Standards for Approval of an Automatic Takeoff Thrust Control System (ATTCS); Final Rule

[Docket No. 24046, Amendment No. 25-62]

AGENCY: Federal Aviation Administration, DOT. ACTION: Final rule.

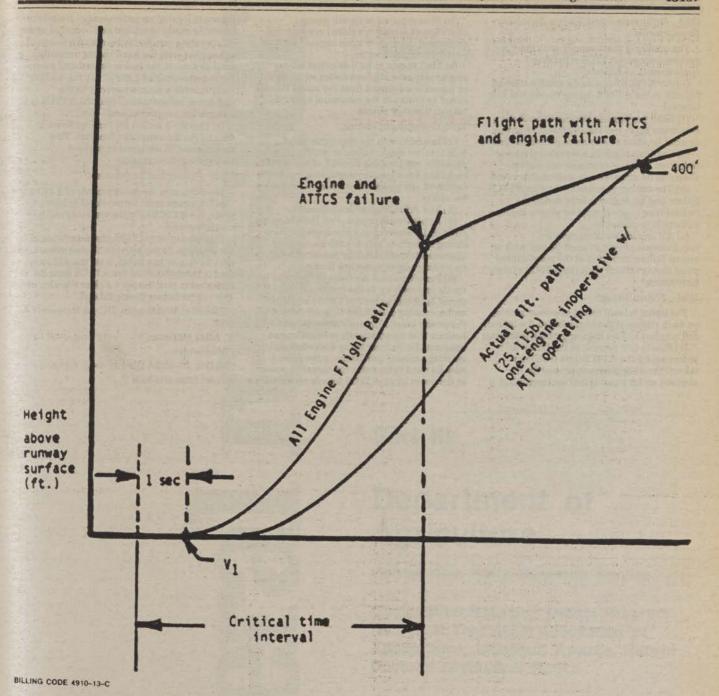
Several comments suggest changing the word "gross" to "actual" in the definition of the "Critical Time Interval" (paragraph 125.2(b)) and in the illustration depicting the definition.

The FAA concurs since the use of "gross" has apparently created some confusion and the meaning is evidently misleading both in the text and in the illustration. Since the word "gross" does not appear in the referenced regulation § 25.115, the word "gross" has been changed to "actual" in both the textual definition (paragraph I25.2(b)) and the illustration. The word "actual" is used in § 25.115(b), although the procedures to determine the actual flight path are defined by § 25.111.

(b) Critical Time Interval. When conducting an ATTCS takeoff, the critical time interval is between V₁ minus 1 second and a point on the minimum performance, allengine flight path where, assuming a simultaneous occurrence of an engine and ATTCS failure, the resulting minimum flight path thereafter intersects the Part 25 required actual flight path at no less than 400 feet above the takeoff surface. This time interval is shown in the following illustration:
